# City of Portland Historic Landmarks Commission

## Design Advice Request #3

### SUMMARY MEMO

**Re:** EA 22-184037 DA – Jefferson High School Development  
Design Advice Request #3 Commission Summary Memo – November 20, 2023

Current

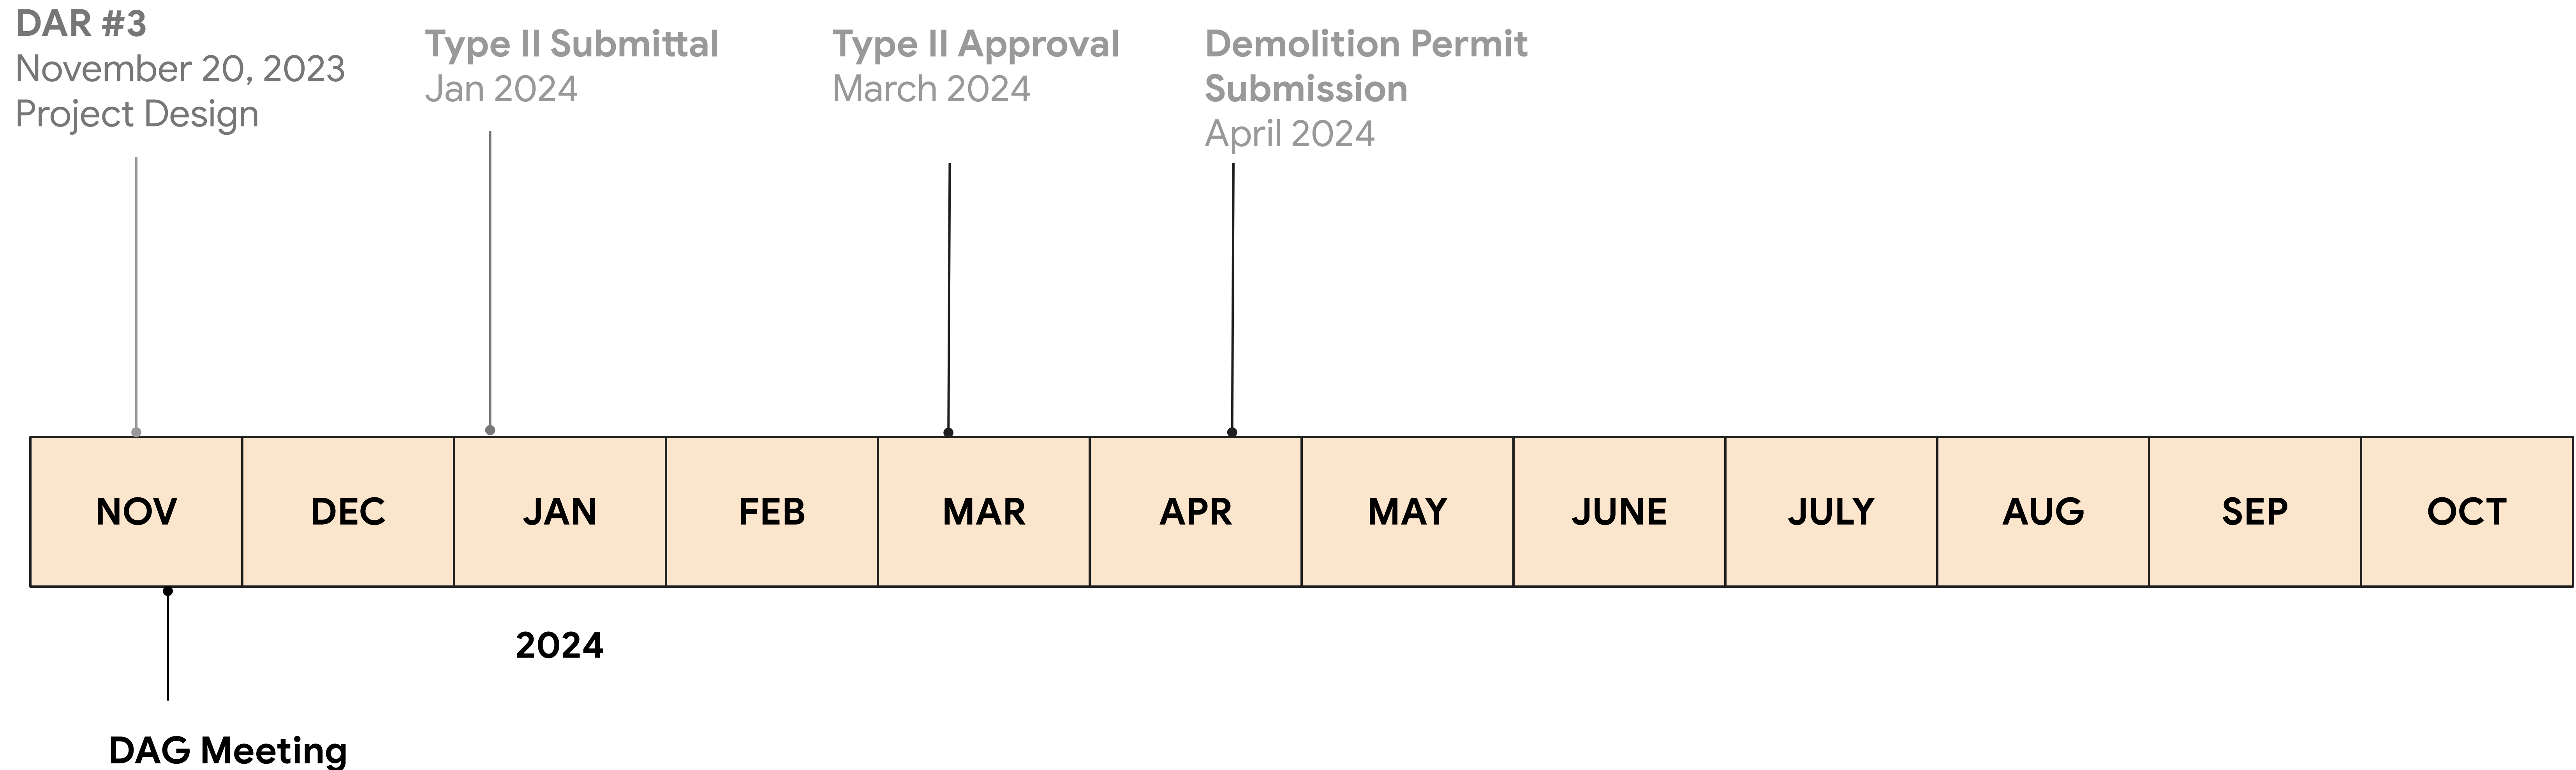
- **Comment:** The east and west elevations of the school have a lot of big blank brick walls. This was commented to be ‘austere’ with little pedestrian scale engagement.
- **Response:** We’ve worked to create more openings on these elevations, improve the ground floor experience with canopies and material changes at entries, and activate the streetscape with landscape.

Window Cadence  
Modified to Relate to  
1909

Added Canopies and  
Material Change at  
Entries

# 1. Re-establish North Entry

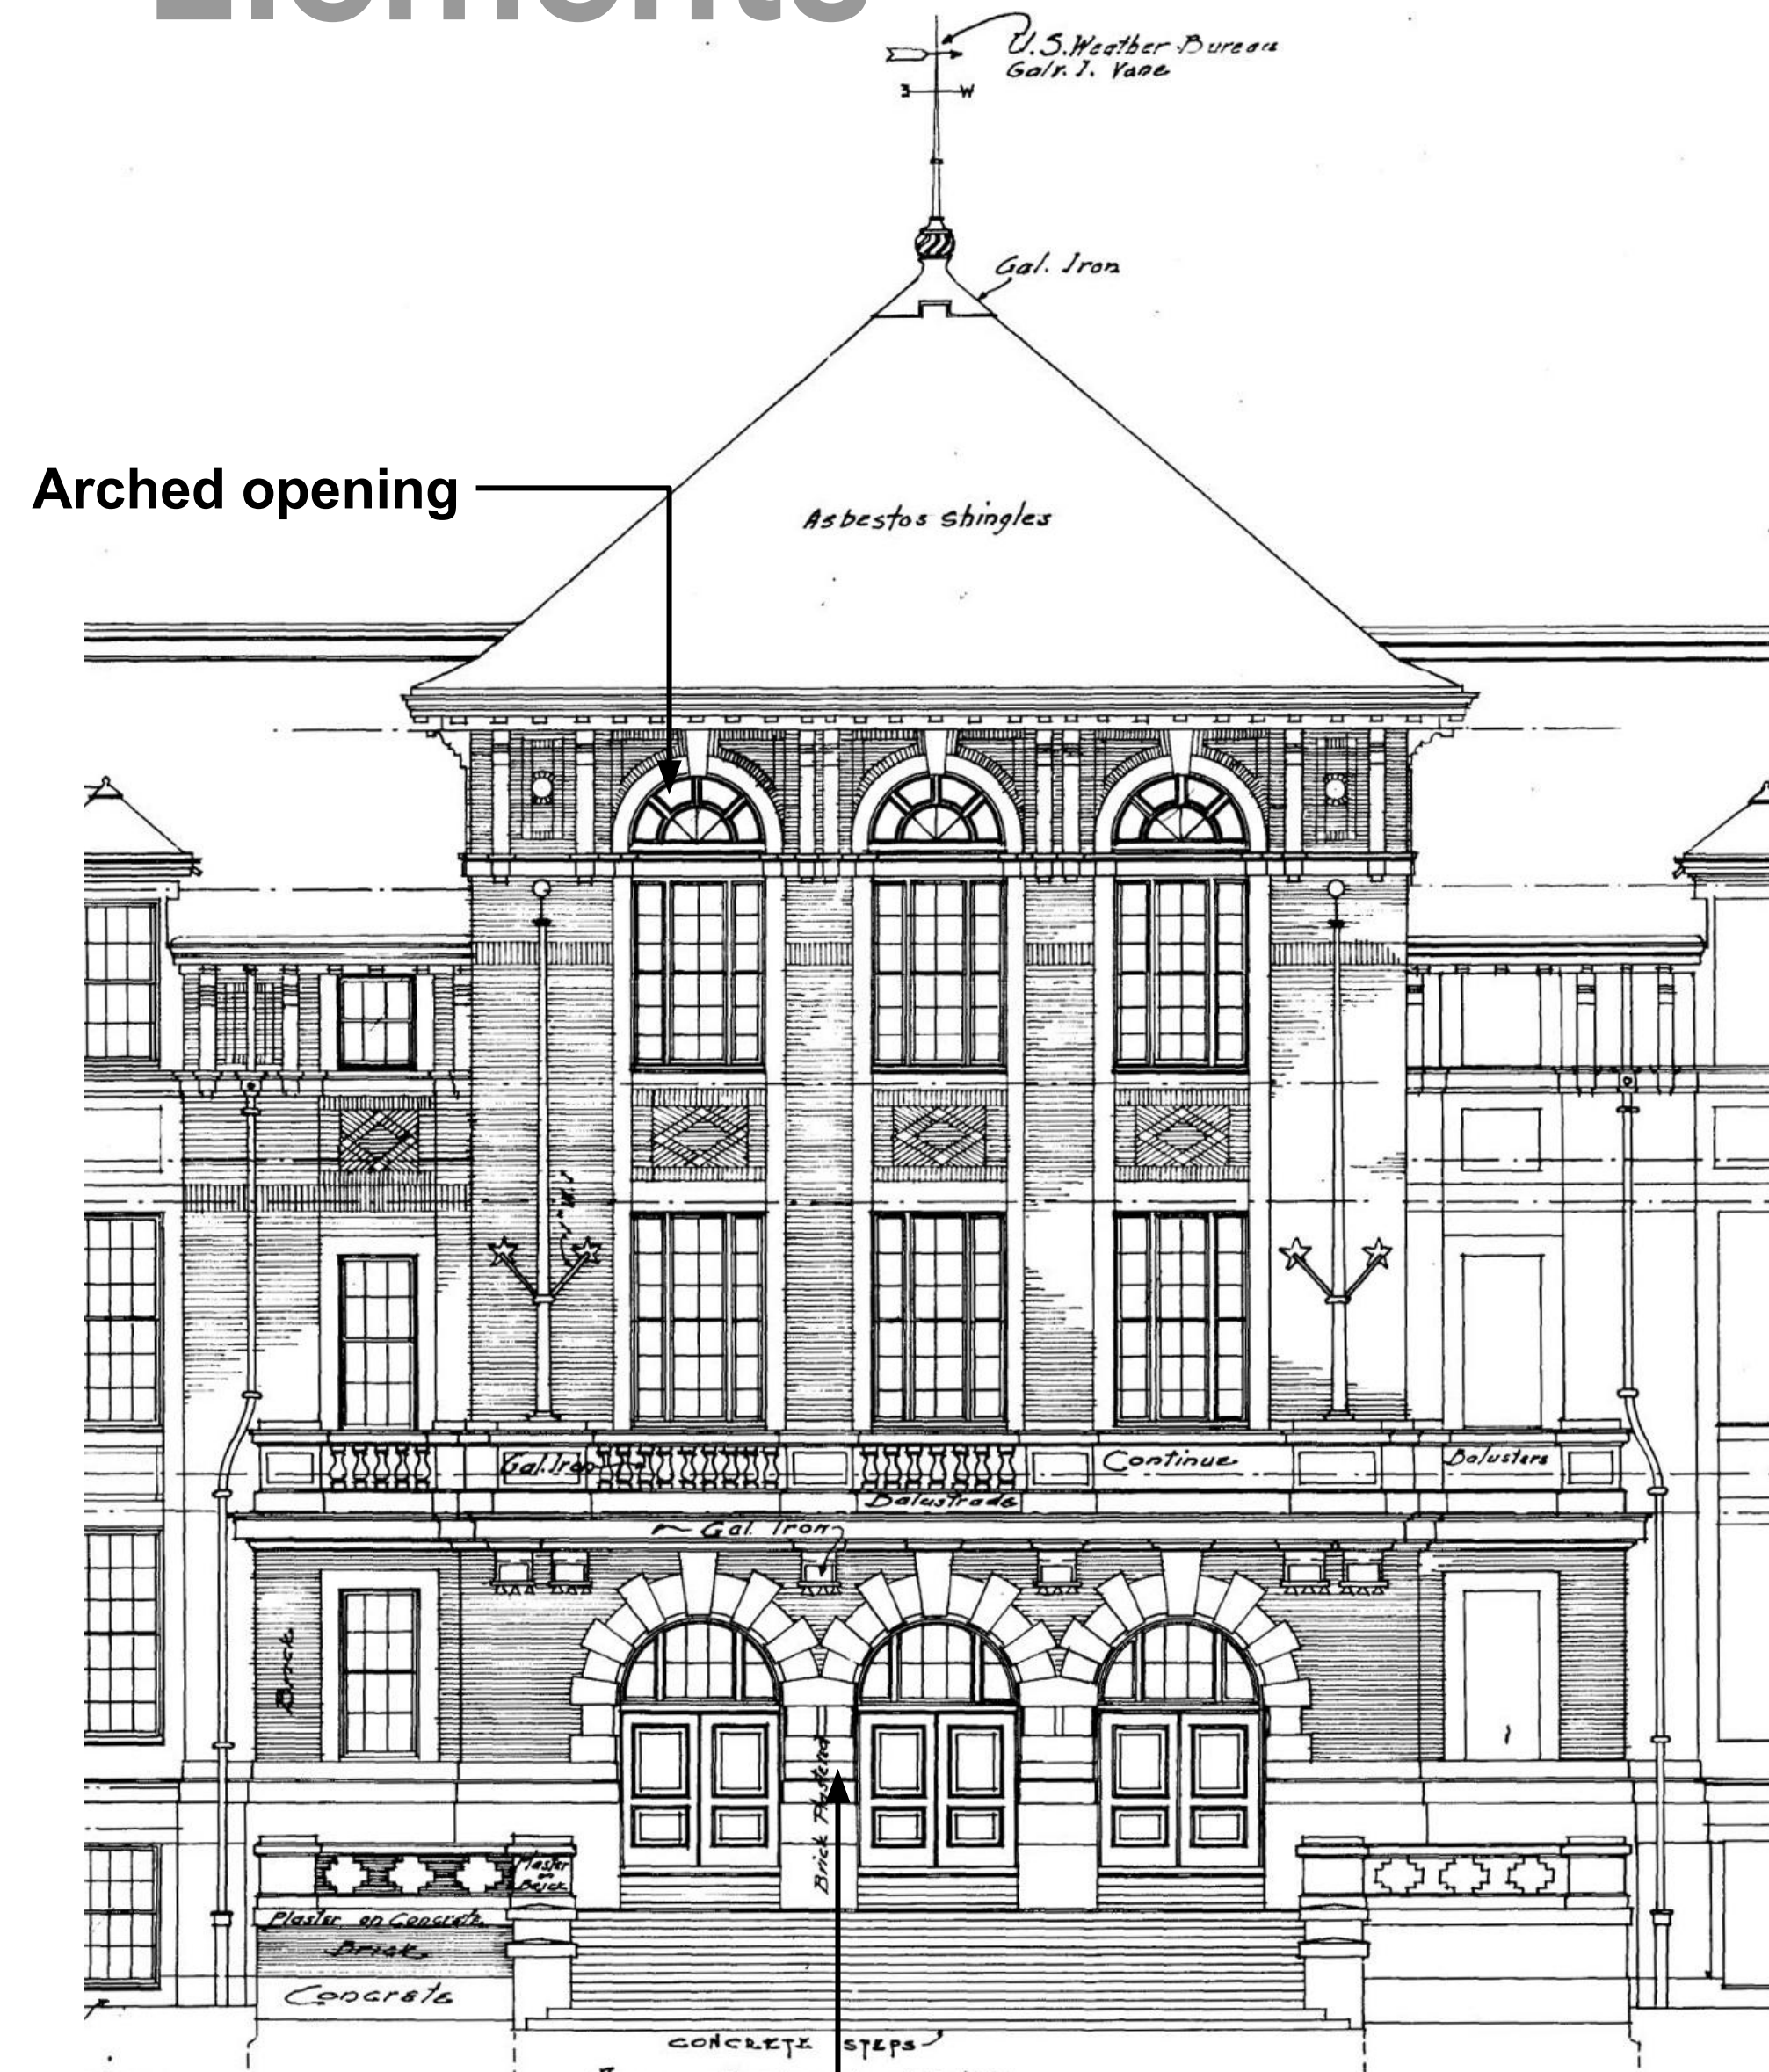
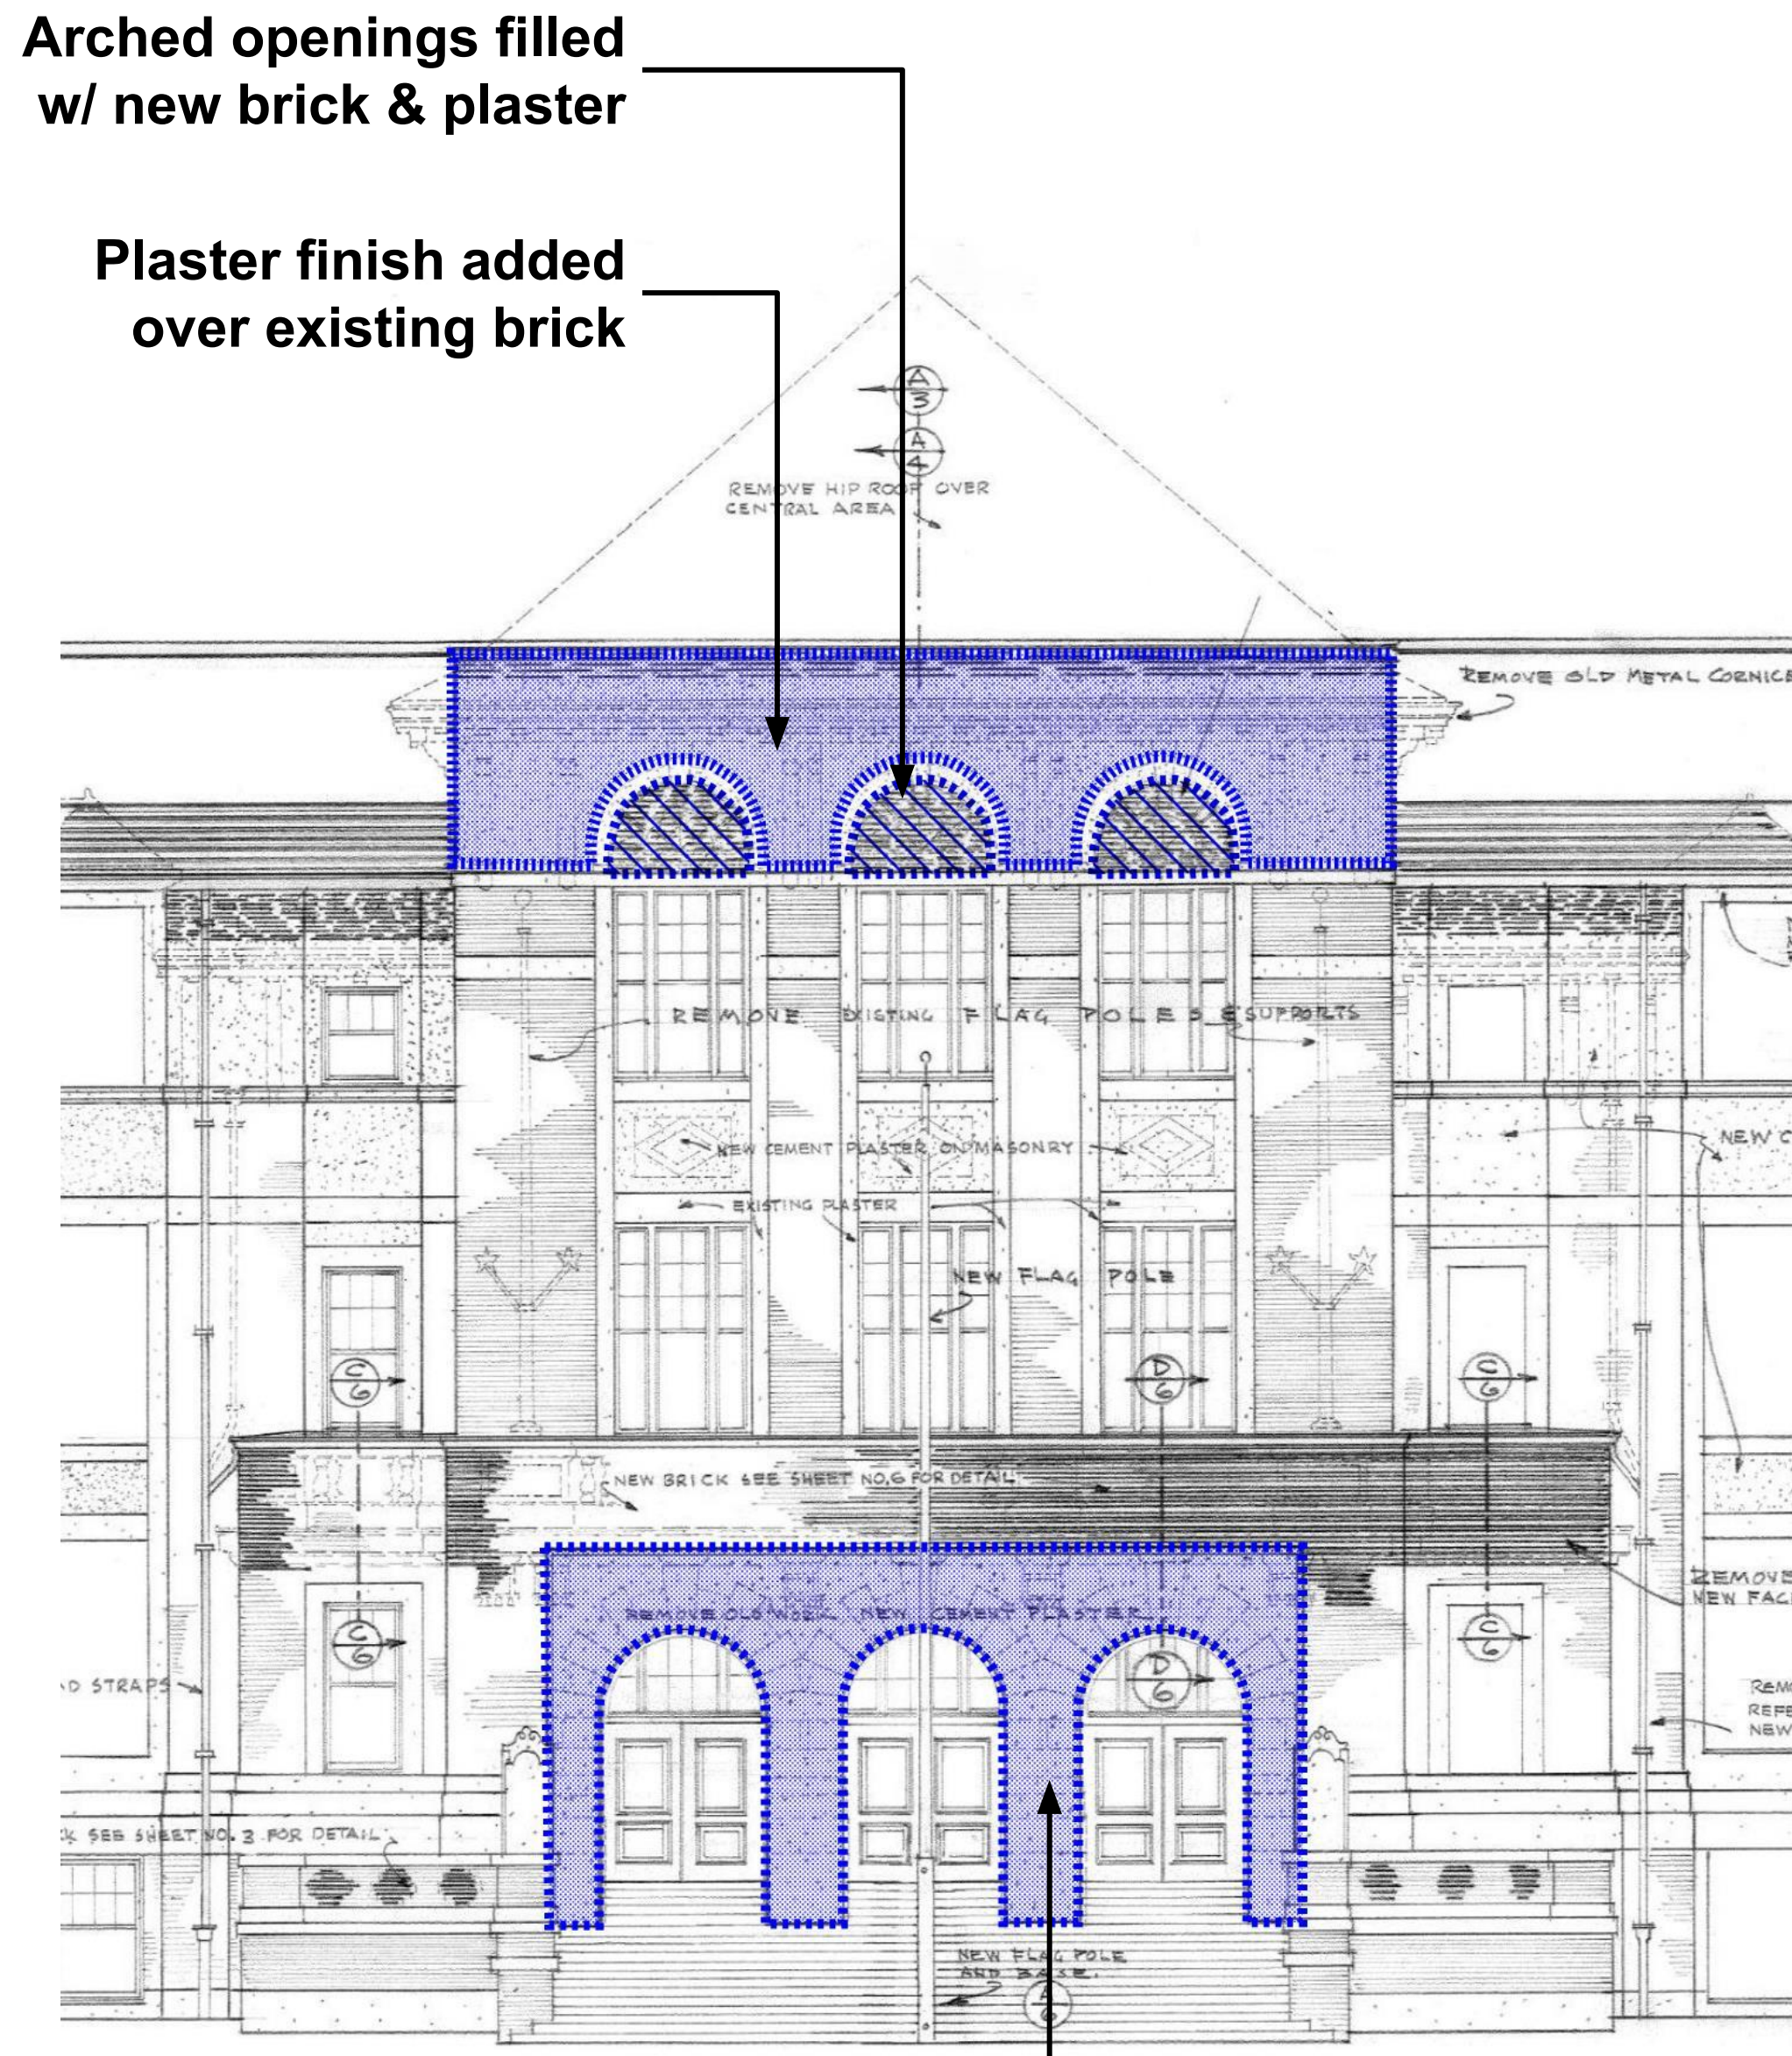
- Commissioners supported the proposed removal of the berm at the north elevation and subsequent alterations to the north elevation's ground floor and at-grade entrance. Commissioners advised the team to make the area inviting and shaded so people will feel free to go through the area.

- Commissioners questioned the need for altering both of the existing east and west entrances on the 1909 building when new accessible entrances are proposed in the new portions of the building.

Remove plaster &, reconstruct brick, if possible
